INDIANA DEPARTMENT OF TRANSPORTATION

APPROVED MINUTES

January 21, 2016 Standards Committee Meeting

<u>Item No. 02</u>	<u>(2016 SS)</u>	<u>Ms. Phillips</u>	<u>pg 10</u>
SECTION 604		SIDEWALKS, CURB RAMPS, STEPS, AND HANDRAILS	
905.05		Detectable Warning Elements	
Standard Drawings:			
604-SWCR-01		LOCATION PLAN FOR SIDEWALK CURB RAMP CURB RAMP DRAWING INDEX AND GENERAL NOTES	
604-SWCR-02		SIDEWALK CURB RAMPS GENERAL NOTES & DETAILS PERPENDICULAR CURB RAMP TYPICAL PLACEMENT	
604-SWCR-03		SIDEWALK CURB RAMP TYPE A PAIRED PERPENDICULAR CURB RAMPS TYPICAL PLACEMENT	
604-SWCR-04		SIDEWALK CURB RAMP TYPE B PERPENDICULAR CURB RAMP COMPONENT DETAILS

INDIANA DEPARTMENT OF TRANSPORTATION
SIDEWALK CURB RAMP
~~TYPE K~~ **Parallel curb ramp**
 SEPTEMBER 2005
 STANDARD DRAWING NO. E 604-SWCR-10

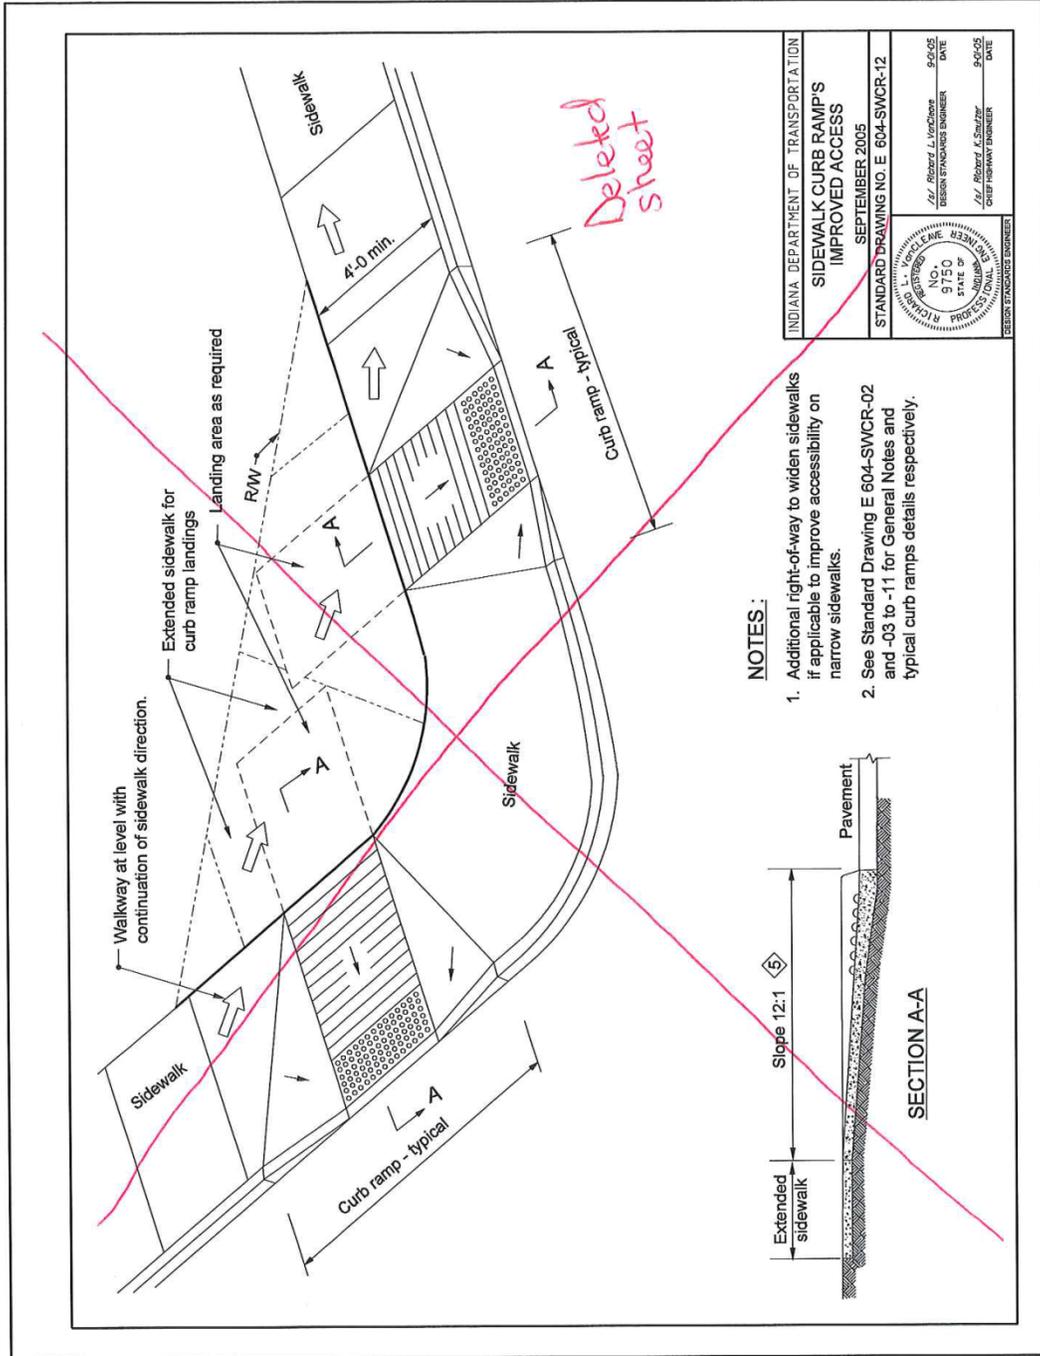
Notes: Deleted

Not deleted, were modified per new drawings PROWAG or for more details.

All curb ramps shall be designed in the construction plans. Only slopes and min. dimensions are shown. Parallel curb ramps have drawings (07-108) showing typical placement and component details.
